Transport for London

Our Ref: CMDN/19/295

Your Ref: : 2019/3091/P

Green Comments – Conisbee Transport Consultant

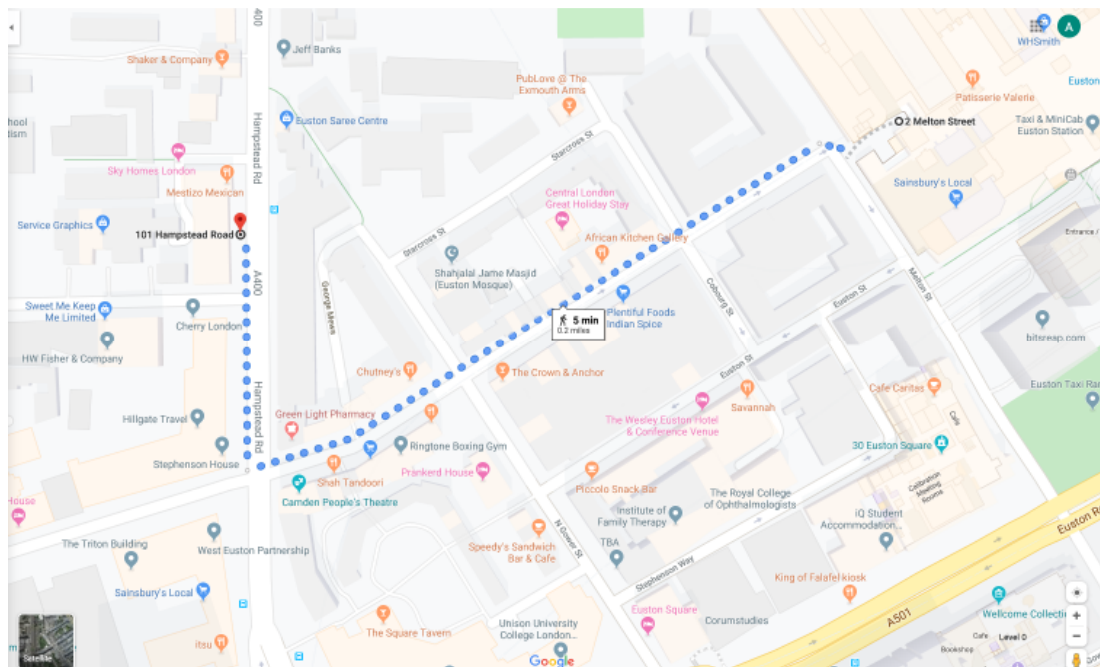
4. TfL object to proposals outlined within the DAS, Servicing and Deliveries Option 1 in which the main servicing and delivery access to the site would be off Hampstead Road. This is because the pedestrianised stretch along North Gower Street provides a direct access for the interchange from Euston Station to nearby bus stops on Hampstead Road and so this proposal would create a conflict of use and raise pedestrian and cyclist safety concerns.

***FBM-** The road is not fully pedestrianised – it's a shared surface with vehicle access still available from the south, up to the gate across the road at the northern end. It is used for emergency access to both the adjacent flats and the former school buildings.*

In addition, its worth noting that map software such as google maps directs you to the bus stop(s) on North Gower Street along Drummond Street and not Starcross Street – as below screenshot.
